ACCESSION NBR: 8402150345 DOC. DATE: 84/02/10 NOTARIZED: YES DOCKET #  
 FACIL: 50-410 Nine Mile Point Nuclear Station, Unit 2, Niagara Moho 05000410  
 AUTH. NAME AUTHOR AFFILIATION  
 LEMPGES, T.E. Niagara Mohawk Power Corp.  
 RECIP. NAME RECIPIENT AFFILIATION  
 SCHWENCER, A. Licensing Branch 2

SUBJECT: *see rpt* Forwards proprietary & nonproprietary structural audit open issue close out info. Affidavit requesting proprietary status for info encl. Proprietary info withheld.

RE: Nine Mile Point Unit 2  
Docket No. 50-410

Enclosed for your review are eight copies of information to close out certain open issues of the NRC Structural Audit. During the Structural Audit of December 12 through 16, 1983 we committed to provide this information.

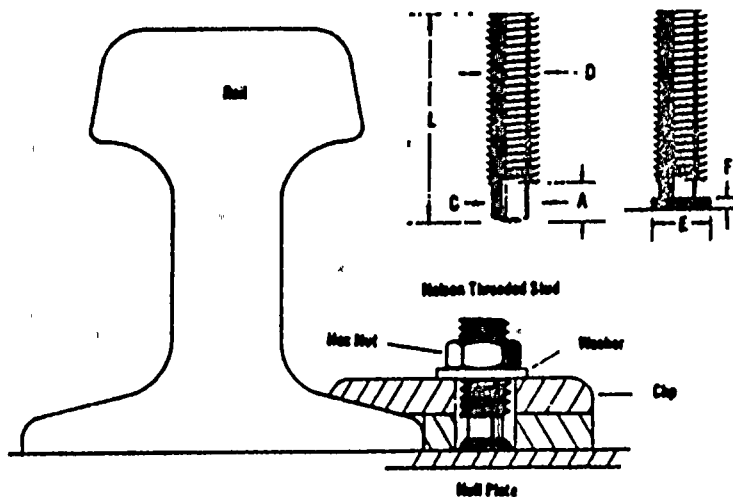
Provide data on strength, material type, and mechanical properties of Nelson studs used in NMP2 polar crane rail support design.

Nelson studs Type CPL, 7/8-inch diameter threaded studs are used in fastening polar crane rail supports. This method of fastening offers easy installation, reduced maintenance, and added safety during installation and operation. The attachment provides the data on material composition, type, strength, etc, from the catalog, Nelson - Construction Applications in Power Generating Plants by (TRW - Nelson Division).
